### Addendum No. 1

#### **2024/25 Pavement Rehabilitation Project Project No. C-610H**

**2024/25 PAVEMENT REHABILITATION PROJECT, C-610H**

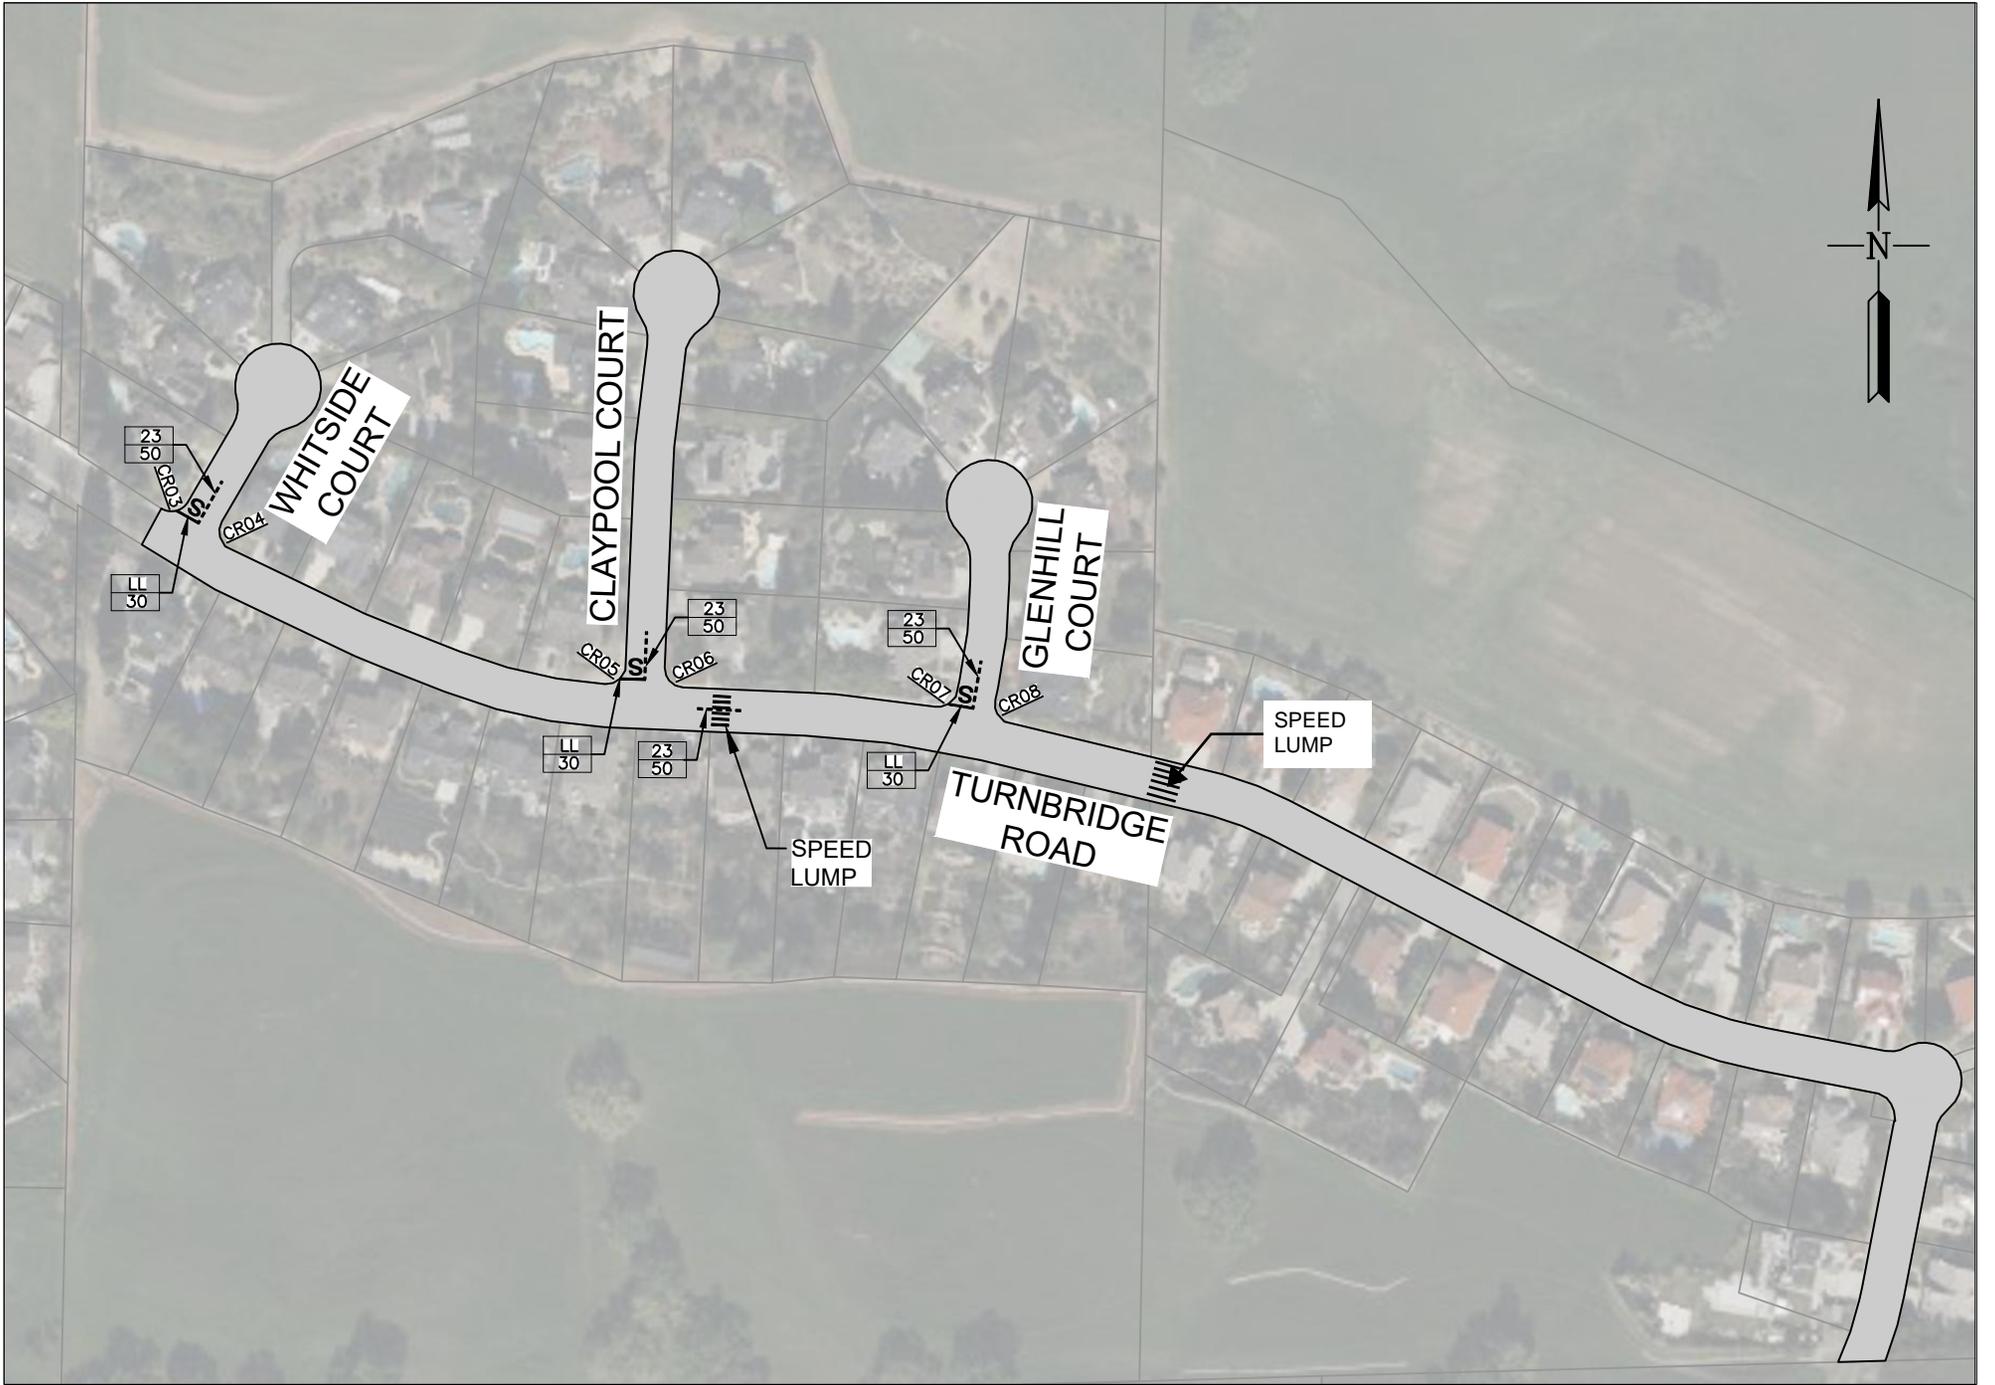
- 3) **Appendix A, Area G (Page 10):** Add speed lump to Turnbridge Road (Revised plan attached).
- 4) **Appendix A, Area G (Page 9):** A callout has been added to the plan to install VDS in place of the loops (revised plan attached).
